BURLINGTON DEVELOPMENT REVIEW BOARD

Tuesday, June 15, 2021, 5:00 PM

To: Development Review Board
From: Ryan Morrison, Associate Planner
Date: June 15, 2021
RE: ZP21-0909CU; 81 Dunder Road

Request: Replace existing detached garage with new detached accessory dwelling unit.

SOUTH ELEVATION
SCALE 1/4" = 1'

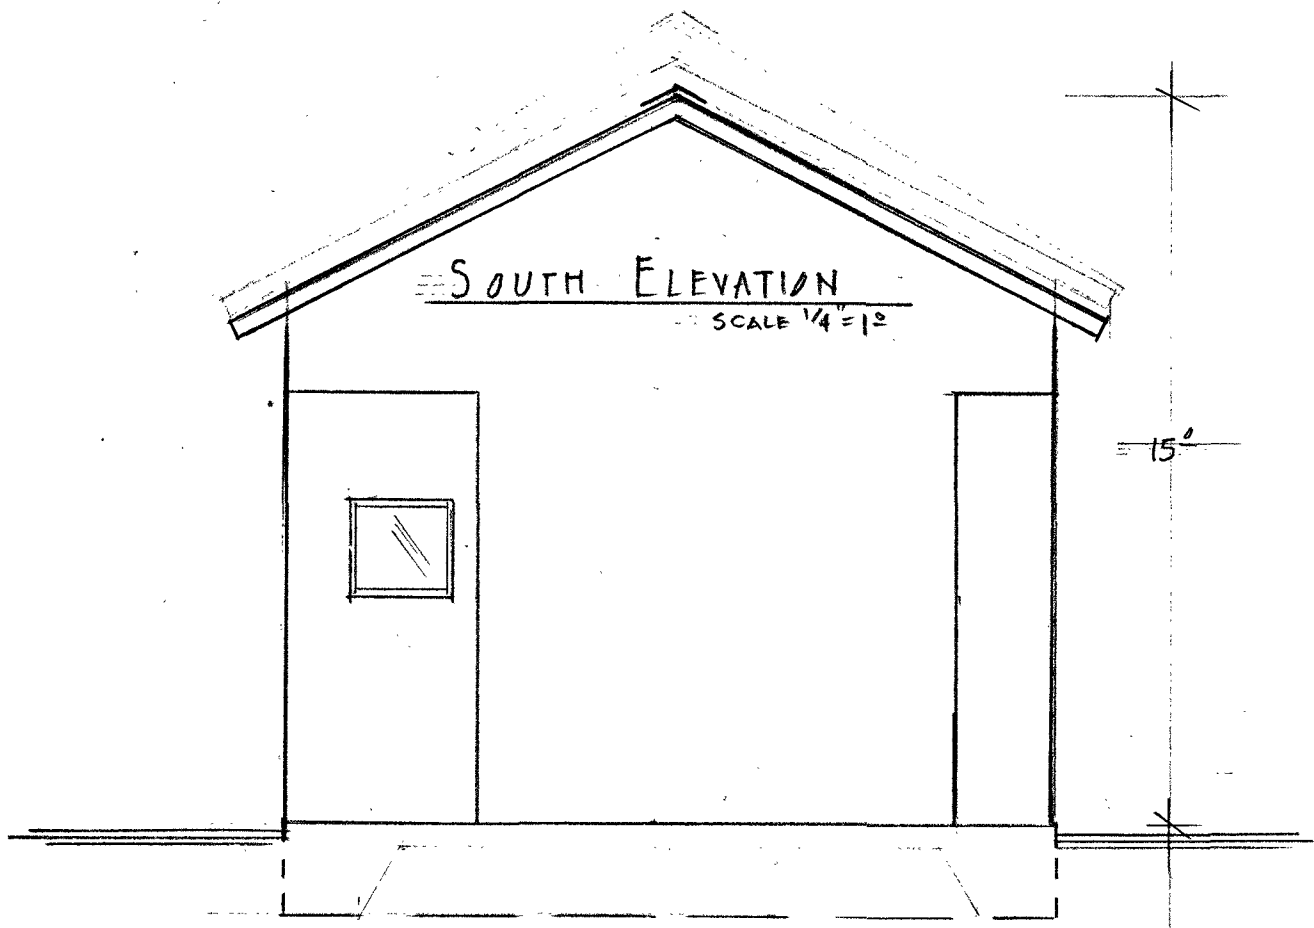
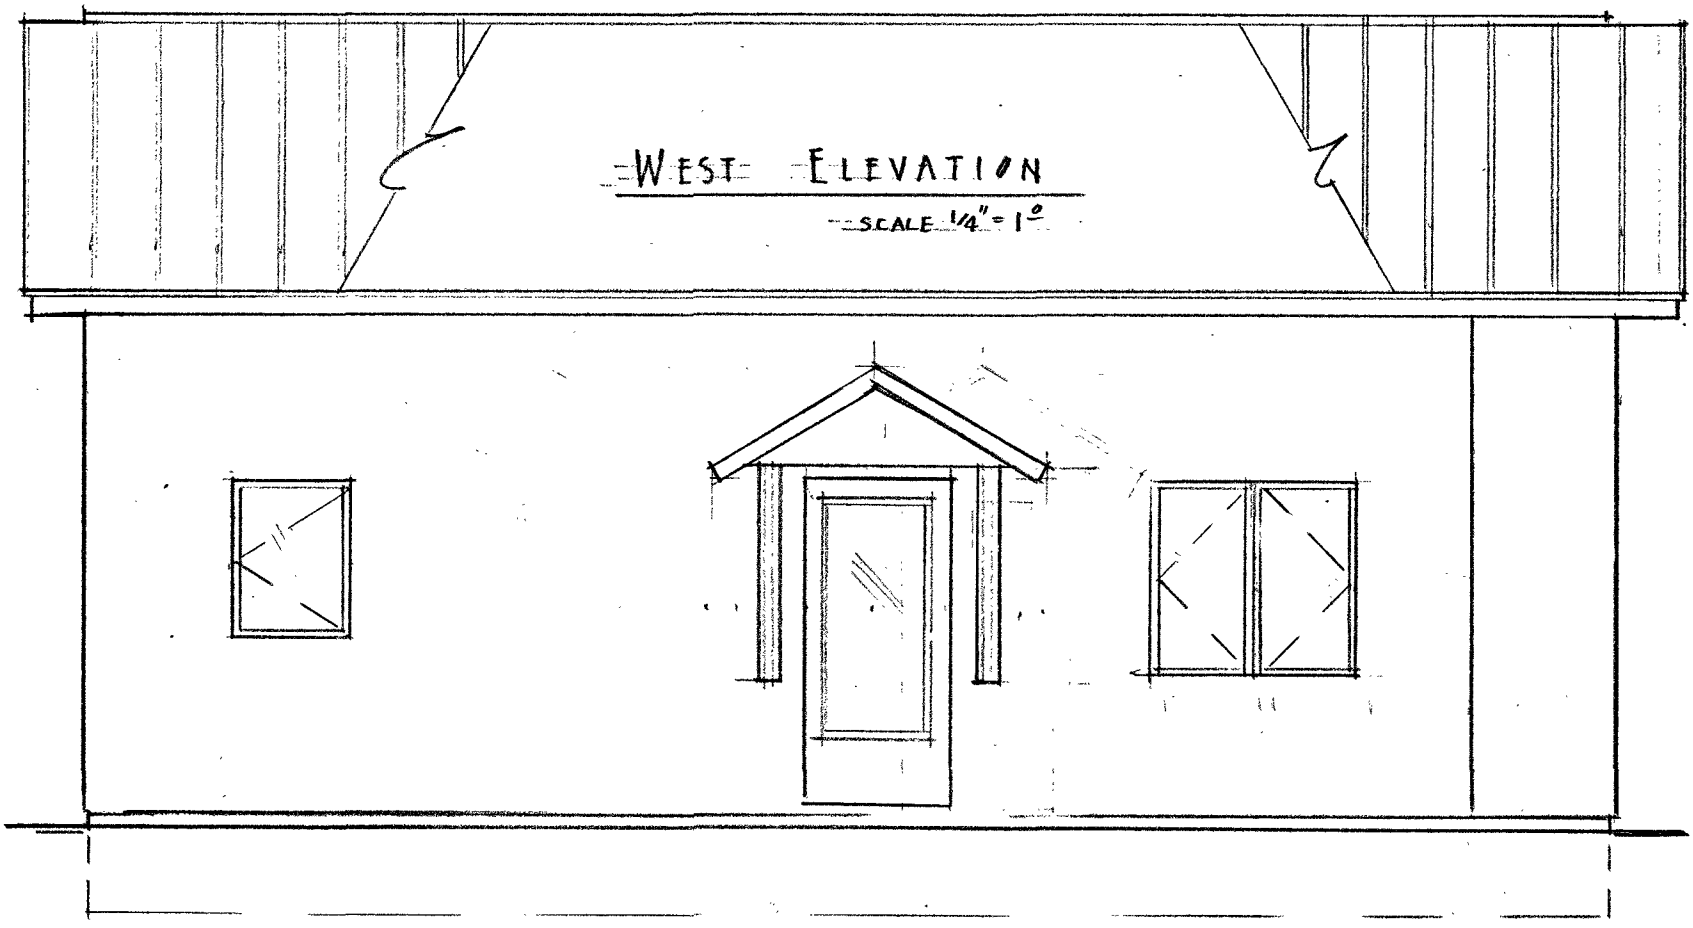
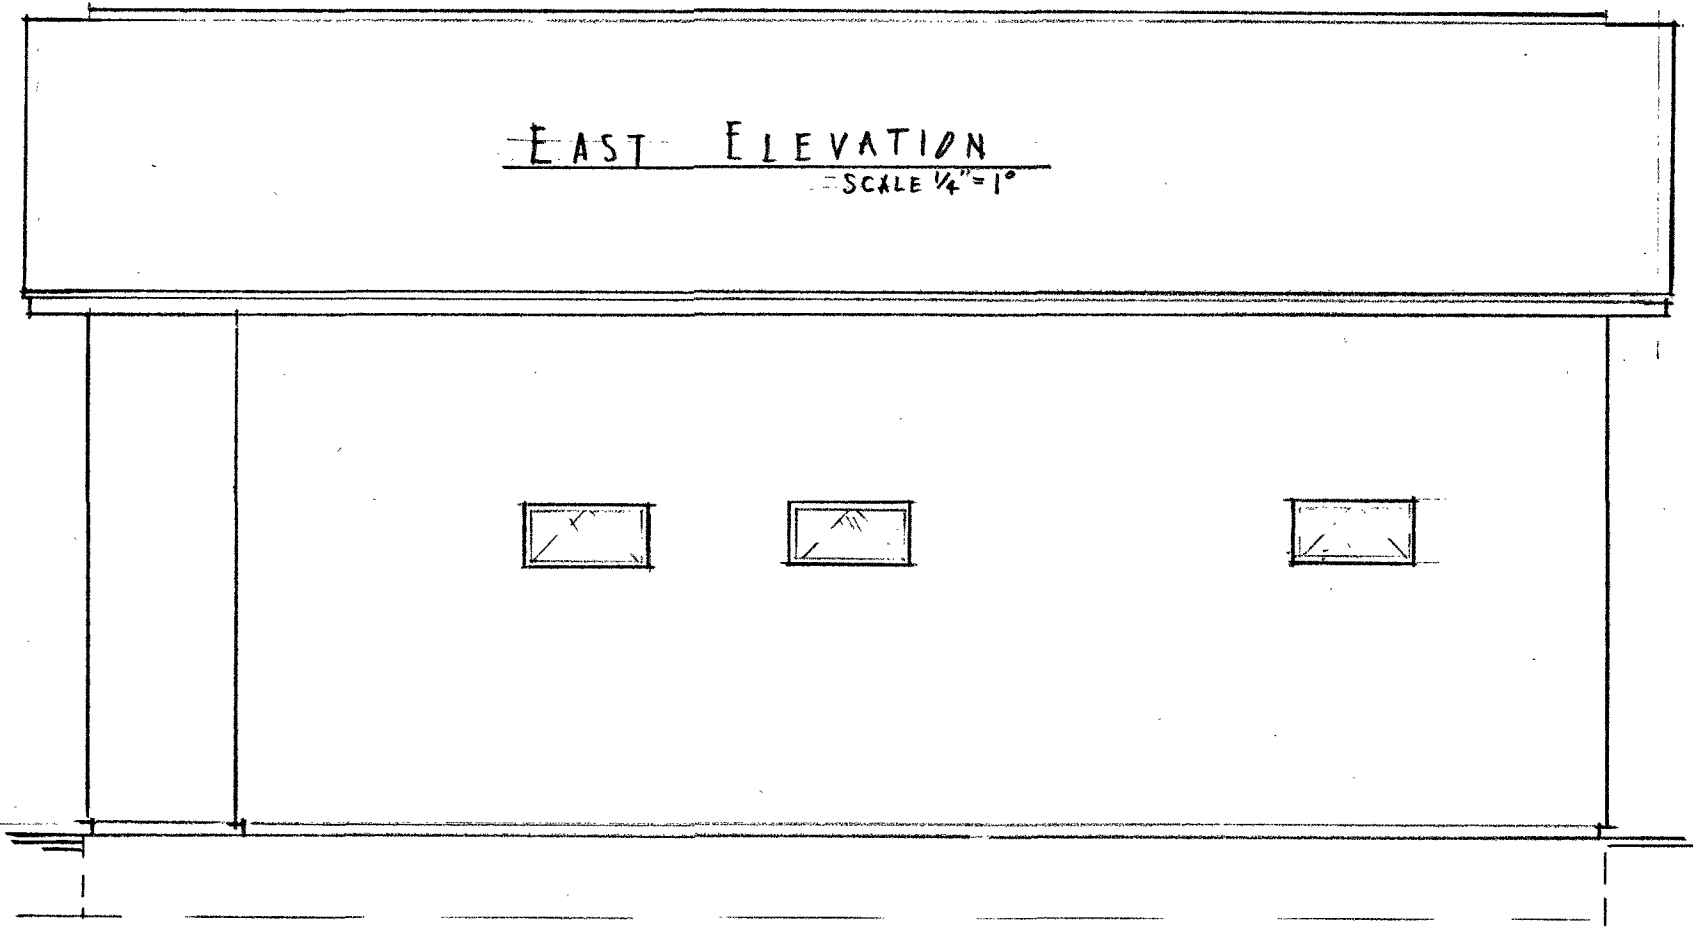
The proposed ADU will be clad in wooden board and batten siding and standing seam metal roofing. Note that no corner boards are depicted in the elevation drawings. If any are proposed, they must be depicted in the elevation plans. The proposed windows appear to be vinyl, but clarification is needed. The materials proposed are of acceptable quality and durability for this new construction. **(Affirmative finding as conditioned)**

15 MYRTLE ST SITE PLAN PROPOSED GARAGE/ACCESSORY DWELLING UNIT

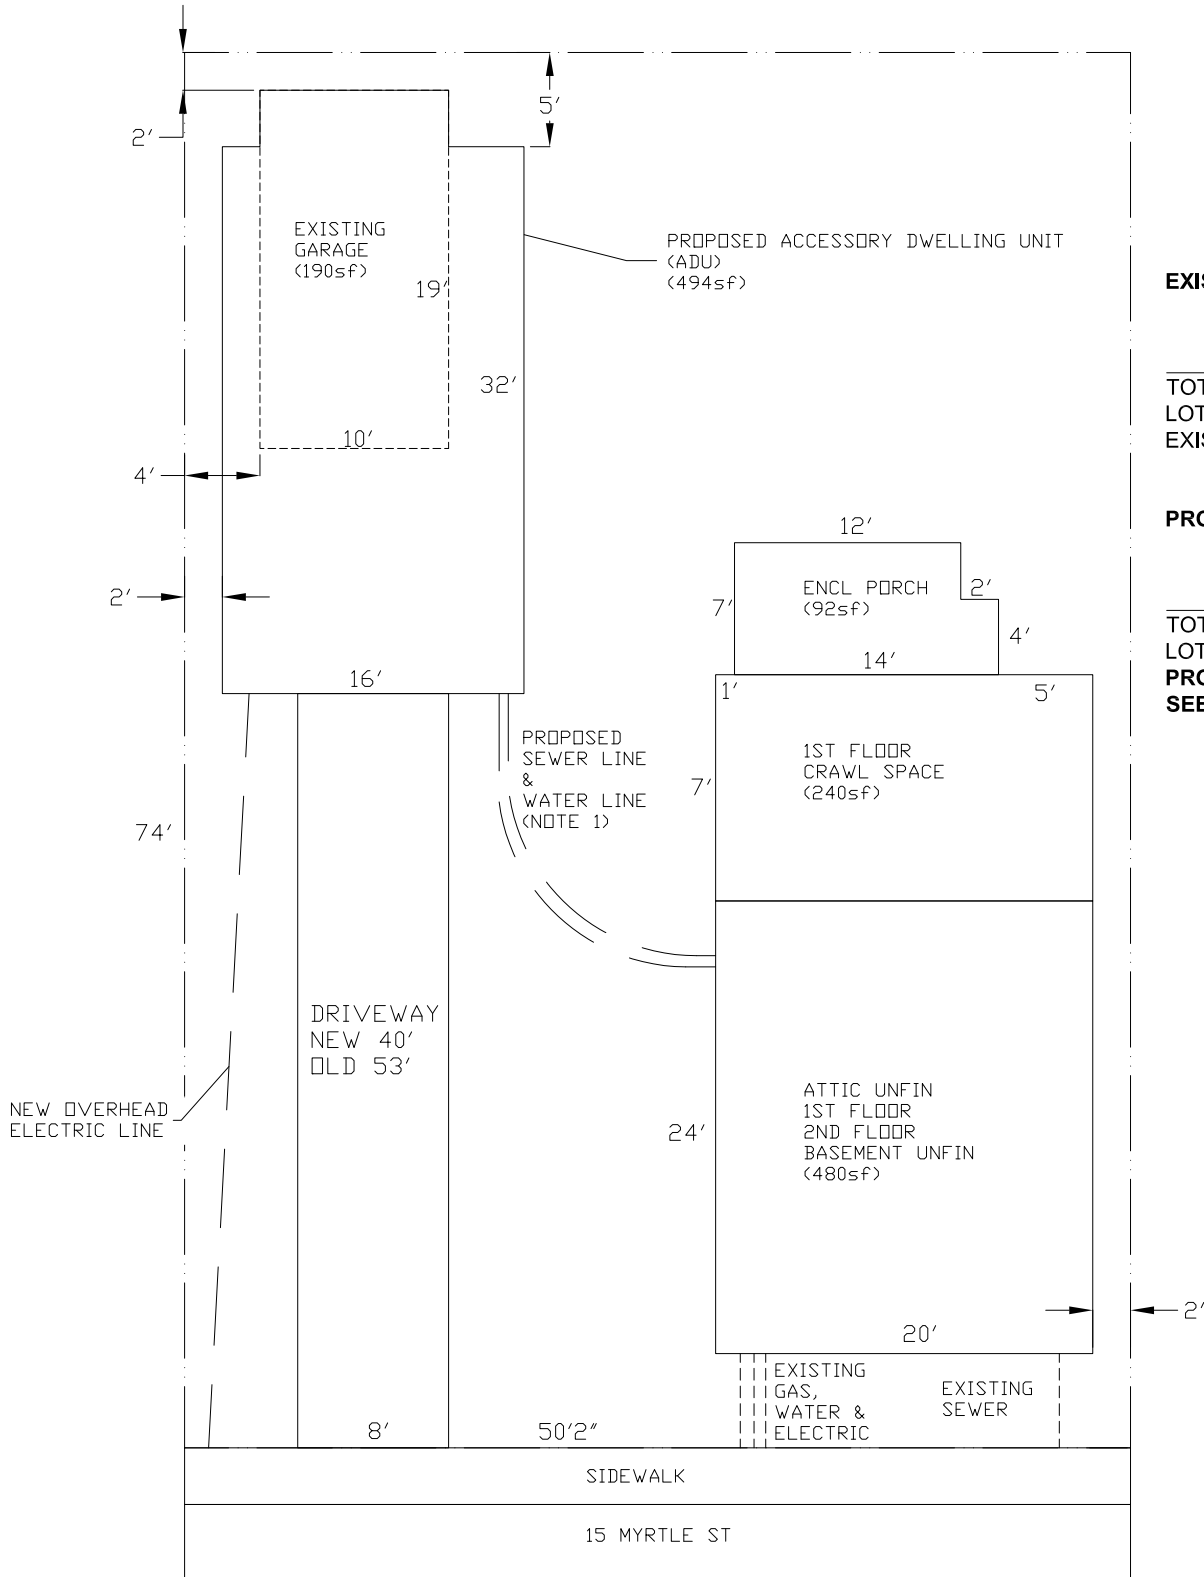
There are no significant natural areas on or near the subject property. Photographs of existing conditions suggest that one or two trees may be removed in order to construct the new ADU. Any existing trees to be removed need to be depicted on the site plan. **(Affirmative finding as conditioned)**

- d. Depiction on the site plan of trees to be removed and a walkway to the west entry;
 - e. Removal of site plan reference to an above-ground utility line (all new utility lines shall be buried);

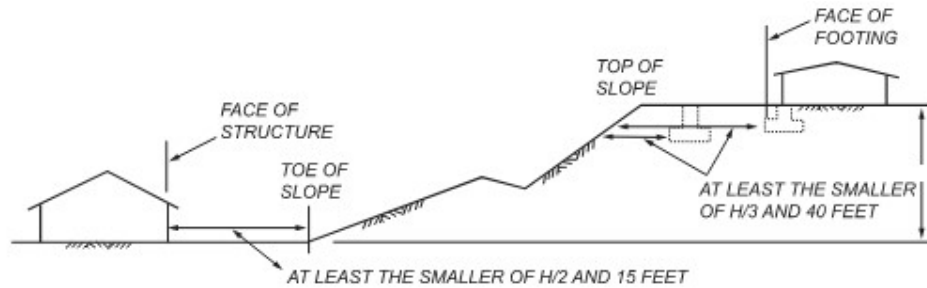
The calculated minimum factors of safety for existing and proposed conditions are shown in the following table:

The FS against sliding for the slope under existing condition exceeds the required minimum FS but given the setback to the crest of slope, we believe having a FS of 1.4 is sufficient for design but more importantly, the proposed construction does not impact the existing slope stability. We believe the FS is slightly lower than ideal because there is an unprotected slope across the street from a failure that occurred during a heavy storm event in October 2019. The slope conditions in this area are steeper than outside of this area and we believe with a shallower slope angle, the FS against slide is at least 1.5.
